220 Railroads

220.2 Highway–Railroad and Light Rail Transit Grade Crossings

Figure 220.2.1 Illustration of Pathway Grade Crossing at Fully-Gated Corridors

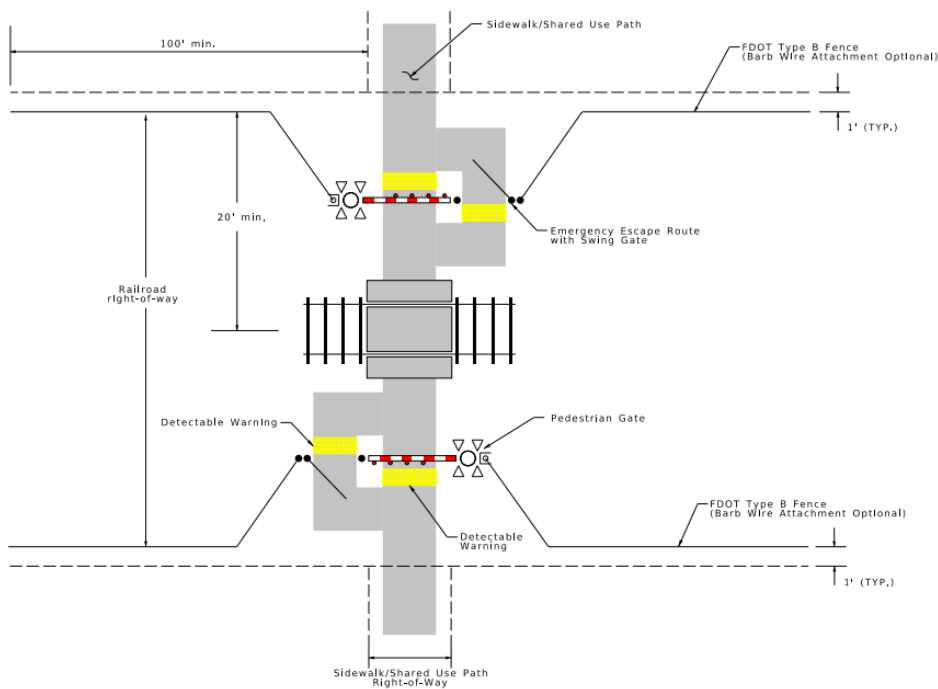
Pathway crossings for higher-speed rail corridors must be grade separated when practicable. When a grade separated pathway crossing is not practicable, provide a sealed corridor with restrictive and channelized grade crossing access in accordance with Figure 220.2.1.

Figure 220.2.2 Low-Speed Roadway and Single-Track Railroad Equipped with Warning System and Connected Vehicle Technologies

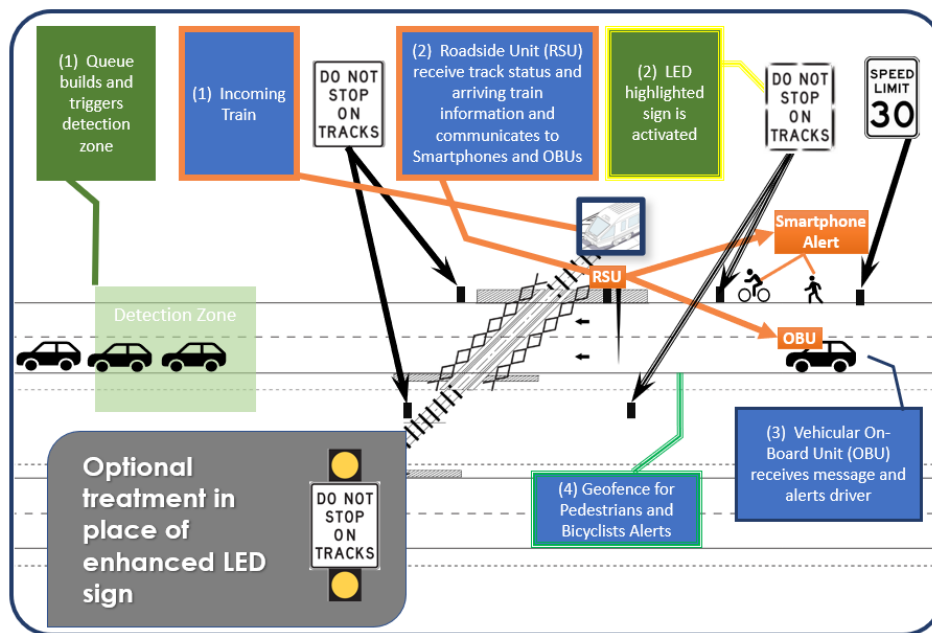
For roadways with posted speeds of 35 miles per hour (mph) or less and crossing a single railroad track, a detection zone may be installed downstream of the railroad crossing. When a vehicle queues within the detection zone, a "DO NOT STOP ON TRACKS" (R8-8) sign(s) enhanced with a white LED border is activated. The sign(s) will be placed immediately downstream of the railroad right-of-way boundary. When used, the enhanced sign(s) will replace existing static R8-8 signs on the downstream side. As traffic queues over the detection zone, the system will monitor the downstream reference point and activate the enhanced sign if the reference point is occupied by a vehicle for five seconds or more.

In addition to what is shown in **Figure 220.2.2**, turn restriction blank-out signs can be installed on side streets in close proximity to the railroad crossing to prevent traffic turning onto the roadway from being caught on the railroad tracks. The turn restriction blank-outs would activate at the same time as the mainline R8-8 enhanced sign activation.

Figure 220.2.3 High-Speed Roadway or Multi-Track Railroad Equipped with Warning System and Connected Vehicle Technologies

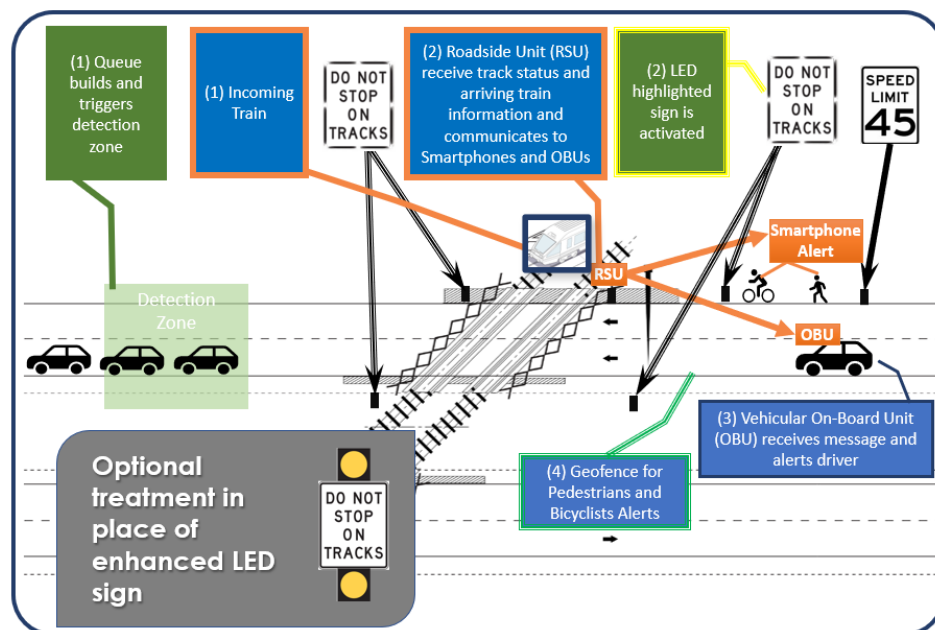
For roadways with posted speeds greater than 35 miles per hour (mph) and crossing a single railroad track, or for roadways with any posted speed and crossing multiple railroad tracks, a detection zone may be installed downstream of the railroad crossing. When a vehicle queues within the detection zone, "DO NOT STOP ON TRACKS" (R8-8) signs enhanced with a white LED border are activated. A minimum of four (4) enhanced signs

are used, placed upstream and downstream of the crossing. The enhanced signs will replace existing static R8-8 signs. If a median is present, it is recommended that R8-8 enhanced signs are placed on the median, especially if multiple lanes are crossing the railroad in each direction. As traffic queues over the detection zone, the system will monitor the downstream reference point, and activate the enhanced sign if it is occupied by a vehicle for five seconds.

In addition to what is shown in **Figures 220.2.2** and **220.2.3**, consider installing turn restriction blank-out signs on side streets which are in close proximity to the railroad crossing in order to prevent traffic turning onto the roadway from being caught on the railroad tracks. The turn restriction blank-outs would activate at the same time as the mainline R8-8 enhanced sign activation.

Figure 220.3.1 Track Section

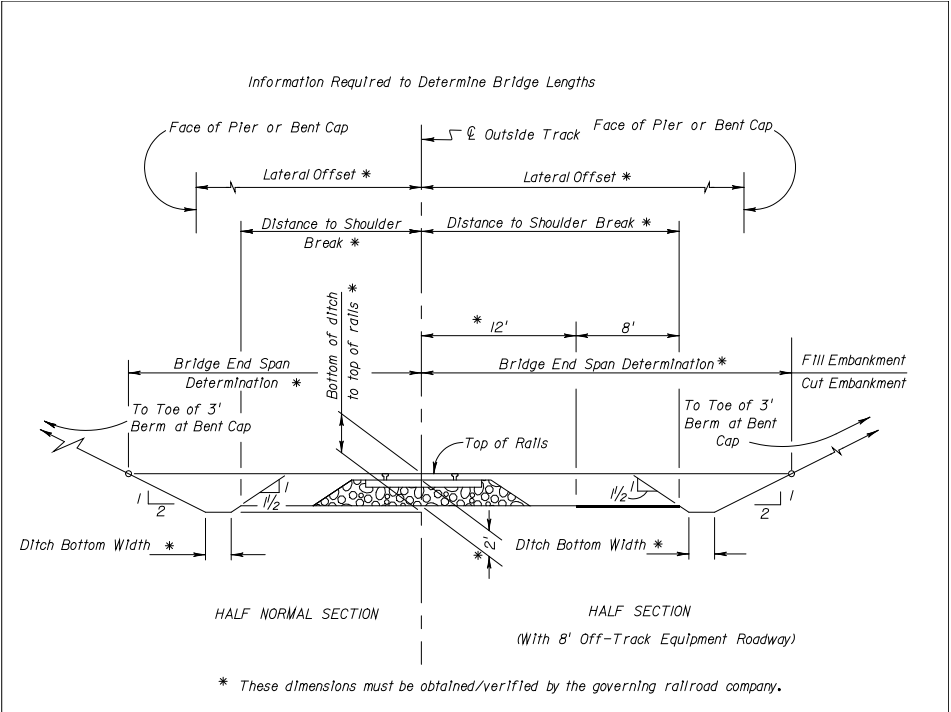
For a roadway over a railroad crossing, measure lateral offset in accordance with **Figure 220.3.1** and **Table 220.3.1**. The railroad company may accept a waiver from standard lateral offset requirements for the widening or replacement of existing bridges.

Lateral offset is measured from the centerline of the outside track to the face of pier cap, bent cap, or any other adjacent structure. Minimum lateral offsets are shown in **Table 220.3.1**.

Figure 220.3.1 shows horizontal dimensions from the centerline of the track to the points of intersection of a horizontal plane at the rail elevation with the embankment slope. This criteria may be used to establish the preliminary bridge length which normally is also the length of bridge eligible for FHWA participation; however, surrounding topography, hydraulic conditions, and economic or structural considerations may warrant a decrease or an increase of these dimensions.
